SUPPLEMENTAL BID BULLETIN NO. 1

**SUPPLY, DELIVERY, INSTALLATION AND TESTING OF VARIOUS SINGLE PASS RICE MILLS  
 (FY 2024 Early Procurement)  
 (PHilMech-RCEF-23-11-34)**

This **Supplemental/Bid Bulletin No. 1** is being issued to clarify, amend and supplement provisions in the Bidding Documents.

## RICE HULL BIN LAYOUT

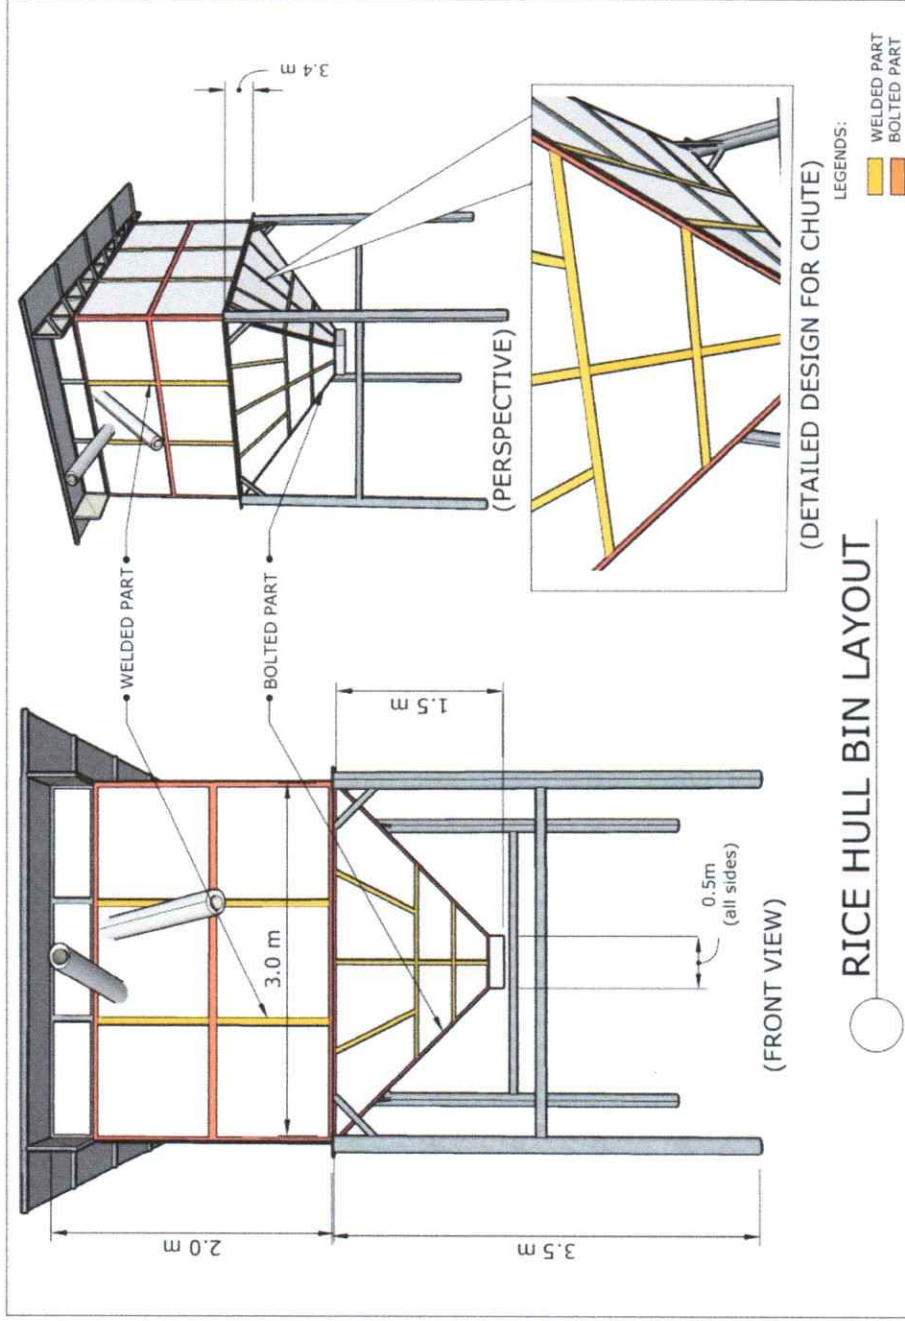
3. Issue / Proposal: Inquiry if the recommended lower ground clearance of the rice hull bin could be lowered.		
Action Taken/Reply: <b>Please see the attached rice hull bin layout.</b>

9. Issue / Proposal: Request for the rice hull bin design.		
Action Taken/Reply: <b>Please see attached rice hull bin layout</b>		
10. Issue / Proposal: Request clarification on the meaning of the "all joints are bolted" specification of the rice hull bin.		
Action Taken/Reply: <b>Please see attached rice hull bin layout</b>

11. Issue / Proposal: Inquiry if the rice hull bin design could be wider and not upright so the angle of repose would not be too high and make it easier for the single-pass rice mill to push the rice hull.		
Action Taken/Reply: <b>The technical specification is retained.</b>
